Rezoning Transportation Analysis

Petition Number: 2018-118

Revision Log:	Date	Description
	10-12-18	First Review
	11-19-18	Second Review

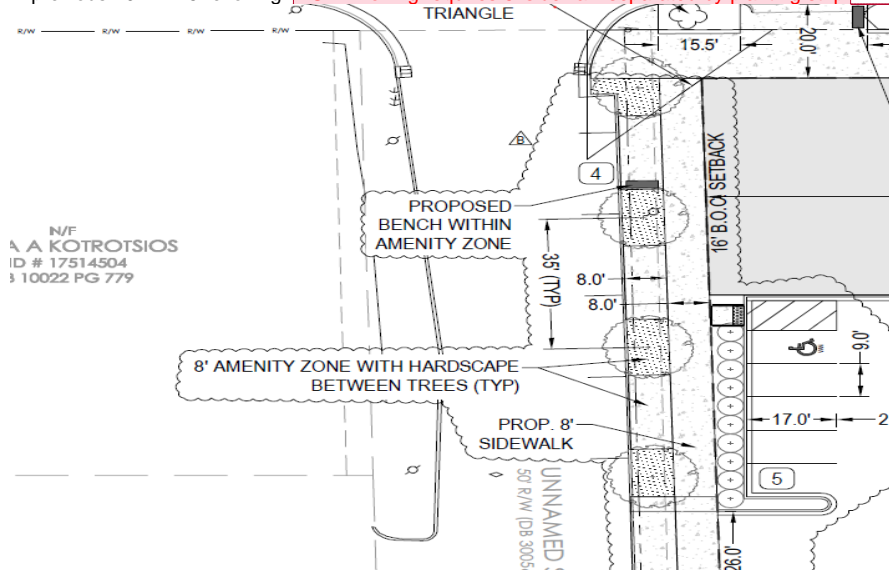
- Curbline** The proposed zoning district has a setback measured from back of the existing or proposed future curbline. The existing curbline is the future location on Montford Drive and on the side street.

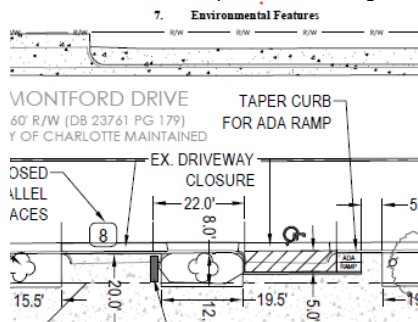
2. ~~Traffic Study~~ A Traffic Impact Study/Transportation Technical Memorandum is not necessary for the complete review of this petition.
3. The petitioner should revise the site plan and conditional note(s) to show amenity zone as approved in previous 2017-116 rezoning. **MUDD zoning requires 6' sidewalk separated by planting strip.**

Commented [W11]: Section 9.8506 (2)(d) "If no street scape plan exists, a six-foot sidewalk is required along all streets separated by a planting strip in accordance with the Charlotte Tree Ordinance [Chapter 21 of the City Code] The Park Woodlawn plan on specifies for Montford but not the "unnamed street"

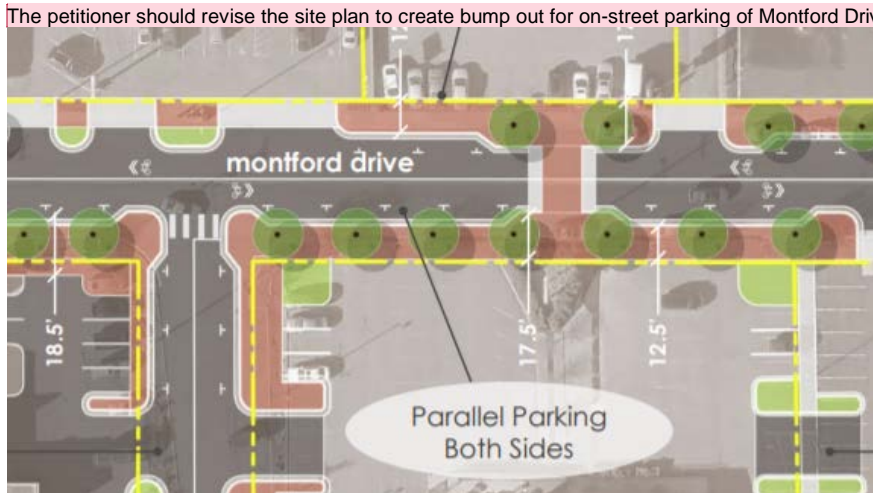
6. The petitioner should revise the site plan and conditional notes to stub across access drive to the adjacent parcel (PID 17514501) per Transportation Policy T-4 in the Park Woodlawn Area Plan.
